Planning Approval Consistency Assessment Form

SM-17-00000111

Assessment name:	Removal of Punchbowl lamp room (Parcels Office) to support underpass upgrade and removal of Punchbowl Road signalised mid-block crossing
Prepared by:	Sydney Metro
Prepared for:	Sydney Metro
Assessment number:	TfNSW55
Status:	Final
Version:	3.0
Planning approval:	SSI 8256 (C&SW)
Date required:	23 September 2022
iCentral number:	SM-22-00407245
© Sydney Metro 2020

Figure 1: Proposed final design finishes with Parcels Office removed.

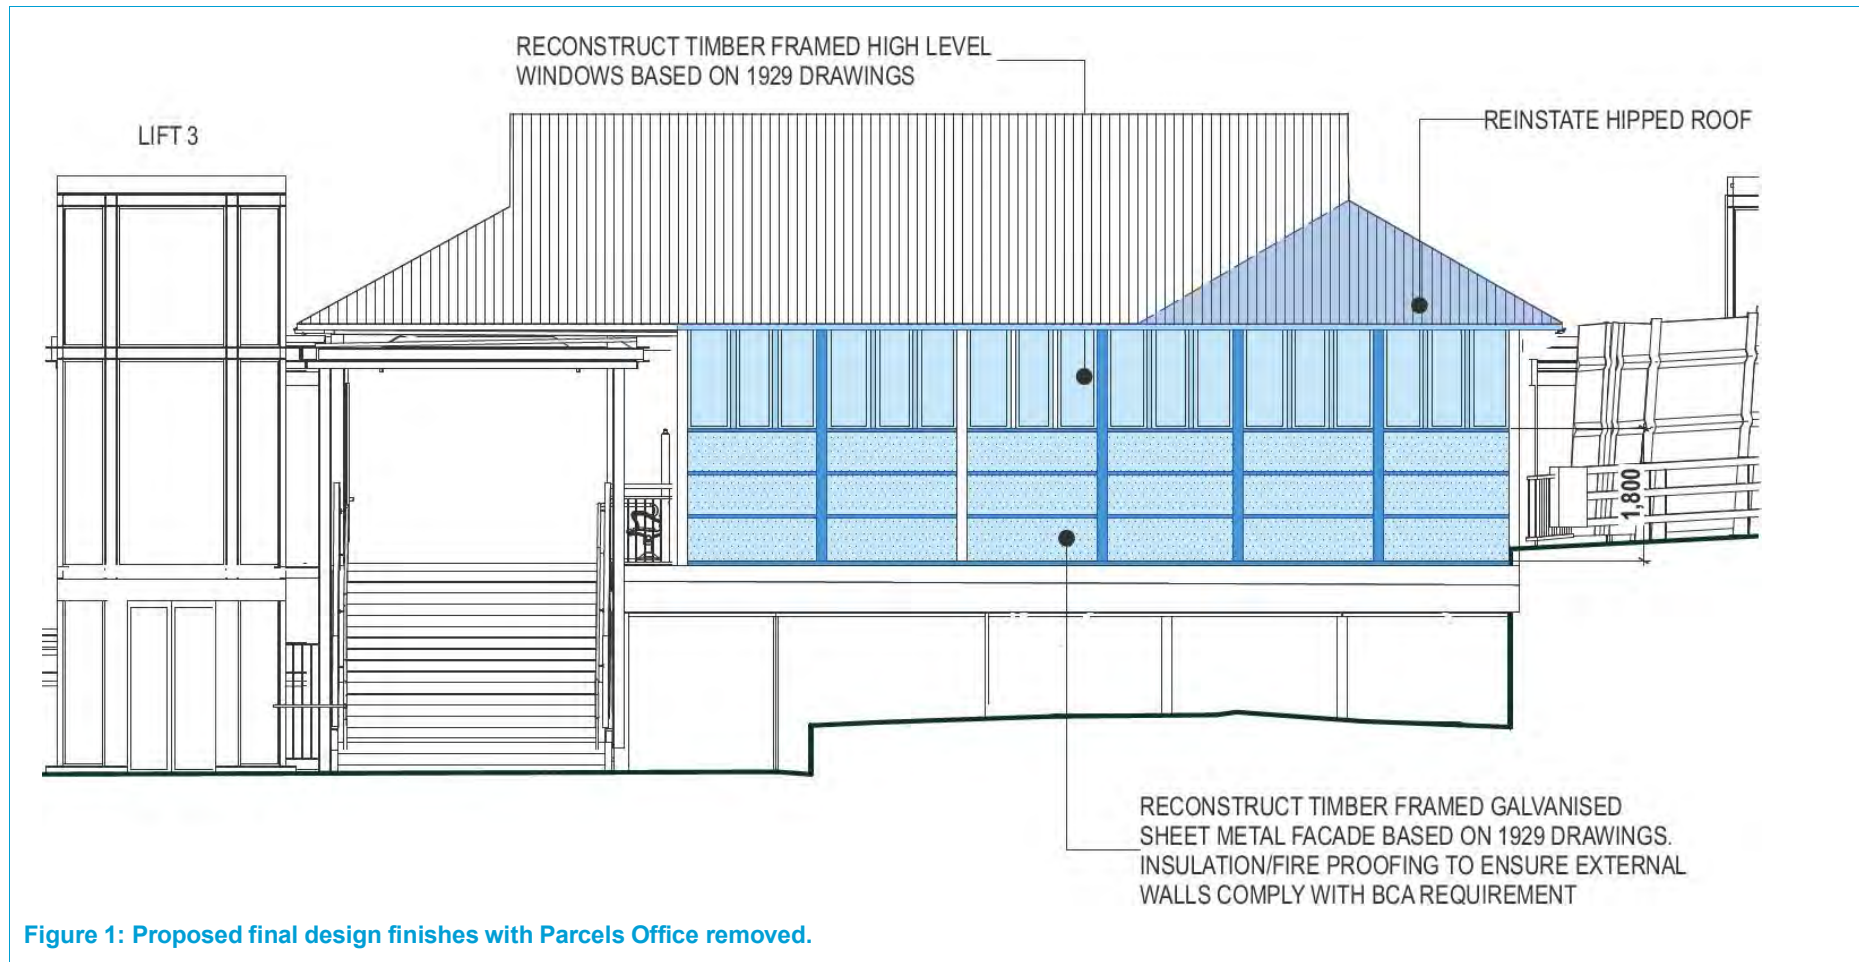
The proposal involves the removal of the Parcels Office and reinstatement of the original form of the Overhead Booking Office (OHBO), including the Dutch Symmetrical Gable Roof to improve the amenity and public safety of pedestrians and cyclists in the area below, and has the benefit of improving the relationship between the OHBO, the Punchbowl Road Overbridge and the overall setting of the station.

The proposal also involves the reconstruction of the timber framed high level windows based on the 1929 drawings and reinstates the galvanised metal cladding in between the timber columns to the base of the façade, whilst maintaining the improved functionality of the Punchbowl Road underpass and plaza.

Figure 2: Proposed Demolition Plan (subject to detailed design).

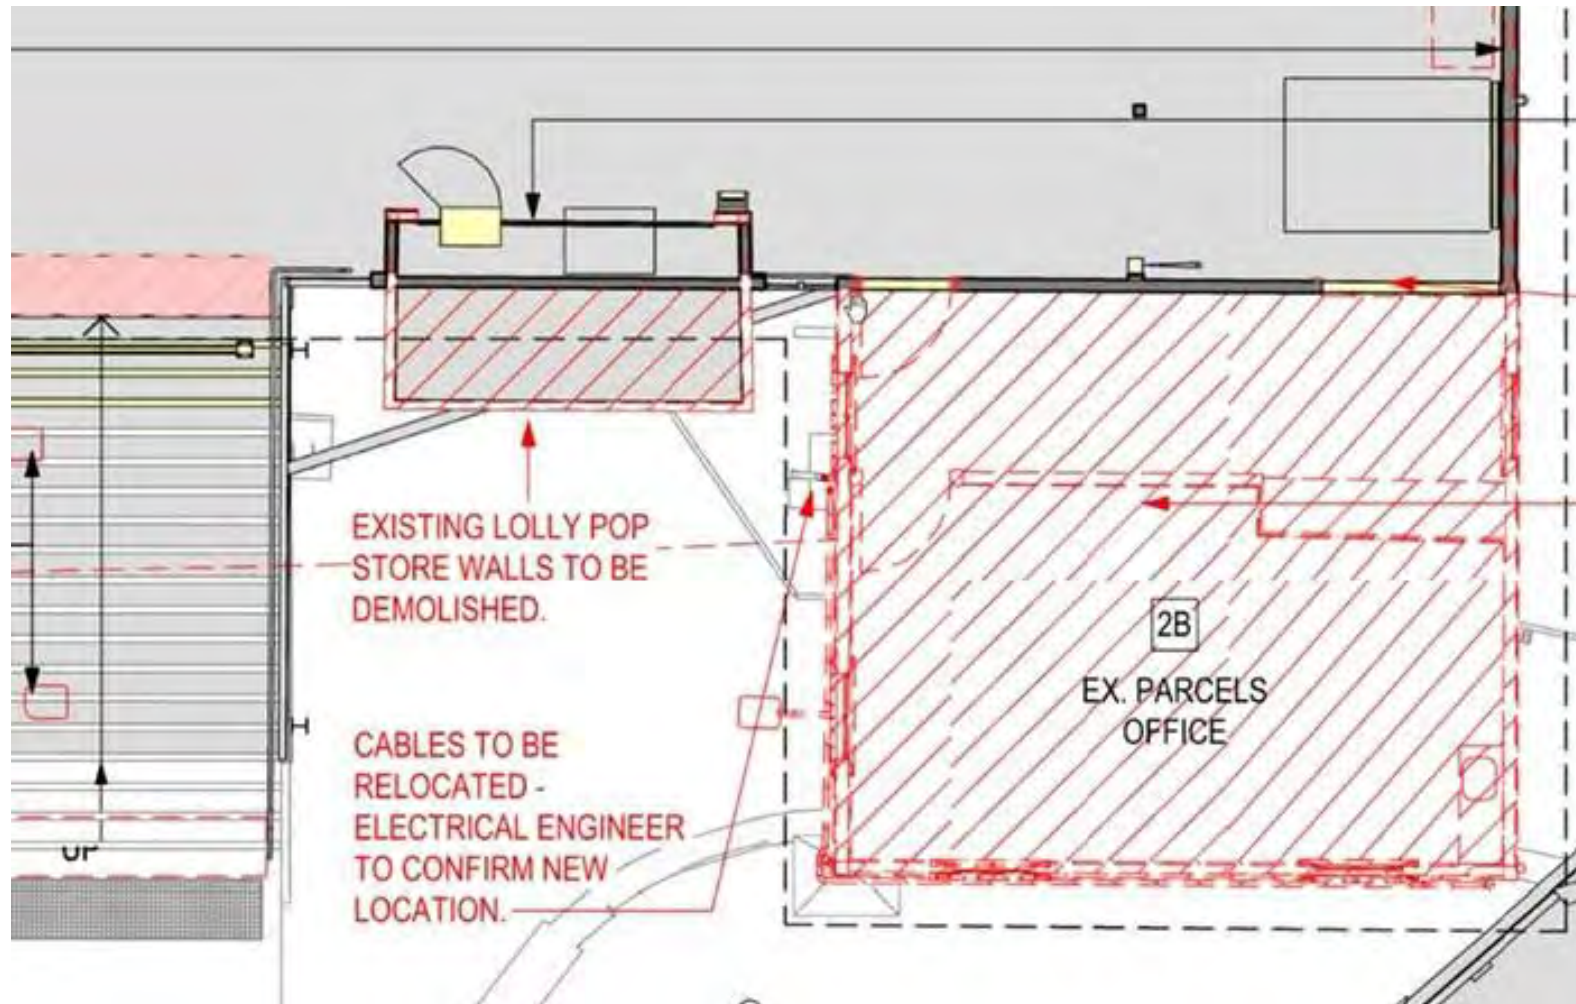
As part of the Parcels Office removal, the existing Lolly Pop store walls are planned to be demolished as an existing demolition as part from the project in the EIS/SPIR. The Lolly Pop store is not heritage listed and was built following project approval. The overall Parcels Office removal plan is shown as Figure 3.

It is important to note that the demolition is not planned to be immediately followed by re-construction of the Dutch Symmetrical Gable Roof but would be made safe and stable during the interim period until re-construction, at this stage likely scheduled for 2023.

Figure 3: Concept design of proposed Punchbowl Plaza and Punchbowl Road Underpass with Parcels Office removed (subject to detailed design).

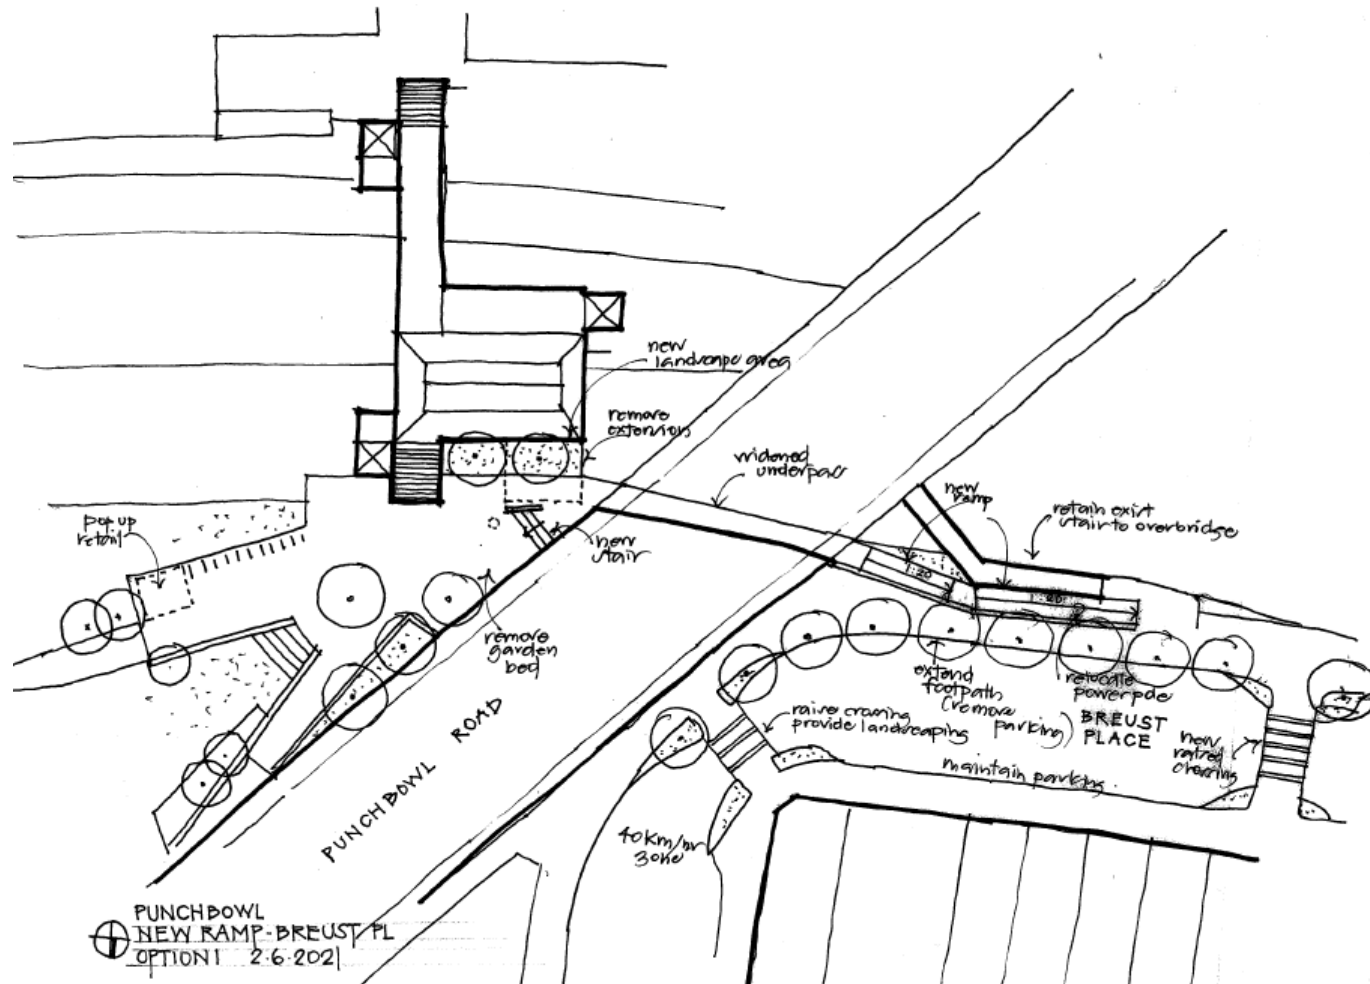
This consistency assessment has been prepared for changes proposed at Punchbowl Station (the proposal). The proposal would include removal of the Parcels Office (lamp room) and adjacent obsolete wall feature (“Lolly Pop store walls”) at Punchbowl Station, as part of the design of Punchbowl Plaza and widening of the Punchbowl Road Underpass. The Parcels Office is recognised as being a part of the curtilage that makes up the Punchbowl Railway Station locally listed heritage item. The proposal also removes the proposed mid-block crossing at Punchbowl Road.

Figure 3 outlines the proposed concept design of Punchbowl Station and Plaza but is subject to further detailed design.

Figure 4: Punchbowl Station – indicative layout of key design elements (Figure 9.9 of the SPIR) – Punchbowl Road mid-block crossing highlighted in red.

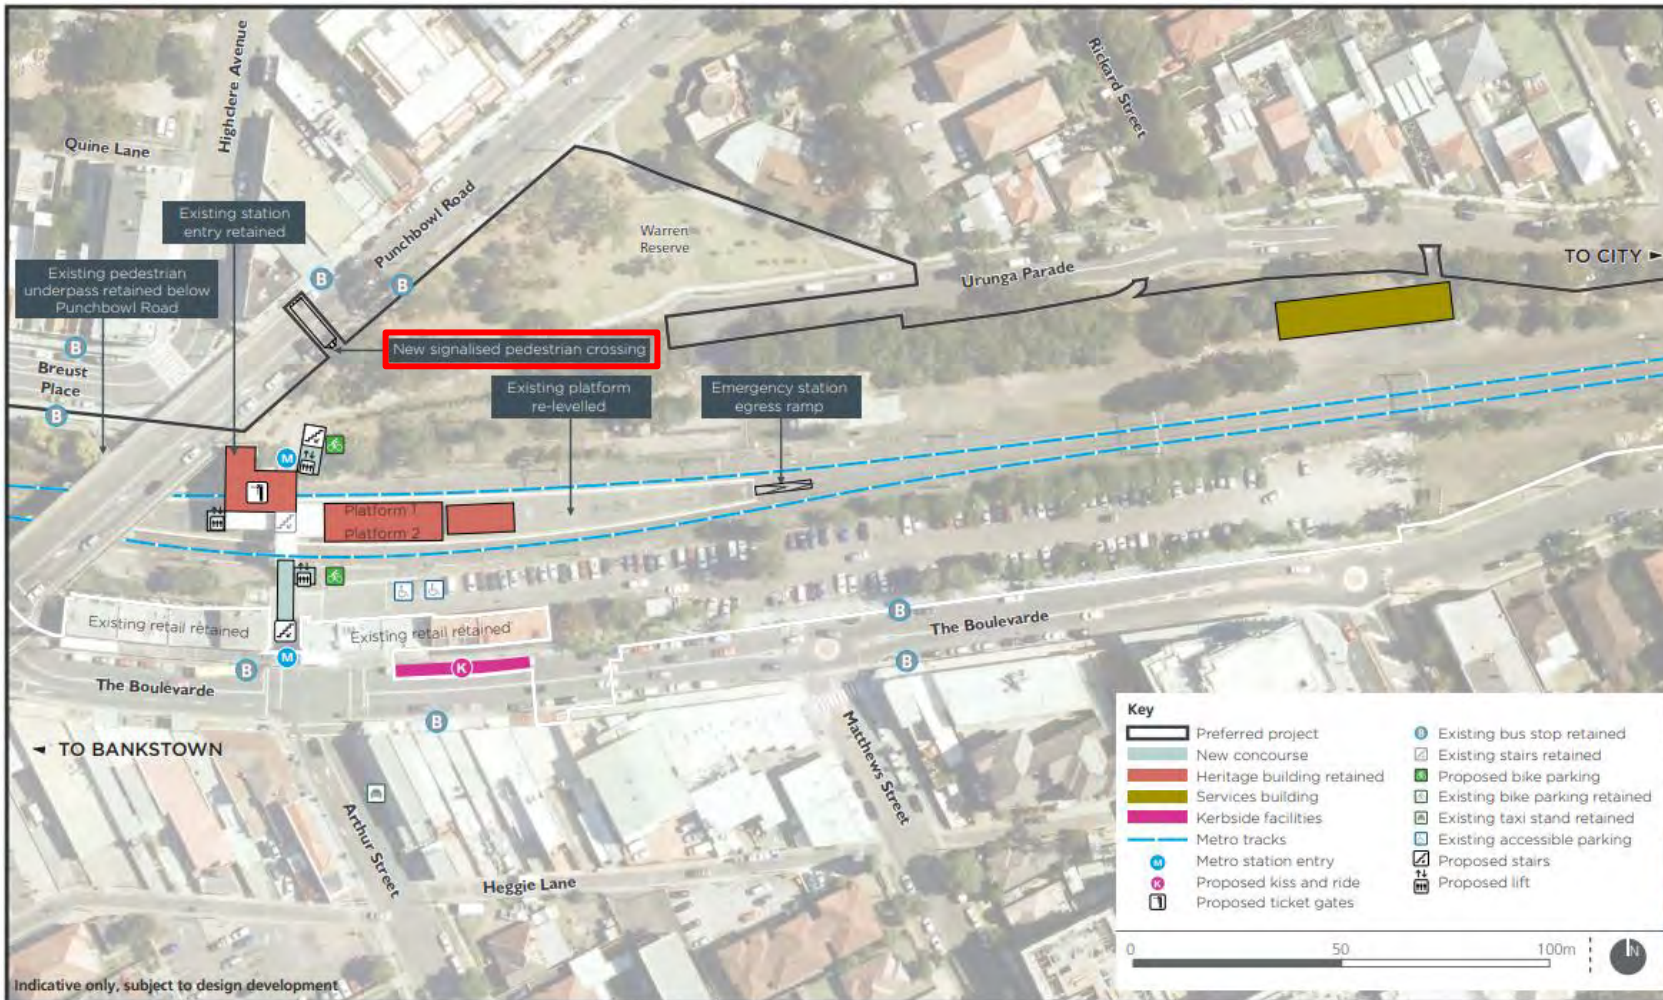
The Punchbowl Road mid-block pedestrian crossing proposed as part of the EIS/SPIR would no longer be delivered as part of the project. The widening of the pedestrian underpass below Punchbowl Road would mean that suitable access is provided to the other side of Punchbowl Road and the pedestrian crossing is not required. The location of the mid-block crossing as proposed as part of the EIS/SPIR is shown in Figure 4.

The proposed enhancements and widening of the underpass provide justification for not delivering the signalised mid-block crossing as proposed in the EIS/SPIR. Not delivering the mid-block crossing would avoid potential congestion, vehicle sight line issues, loss of parking, and associated business impacts. Delivery of the proposed mid-block pedestrian crossing is also not supported by key stakeholders, including TfNSW and local council.
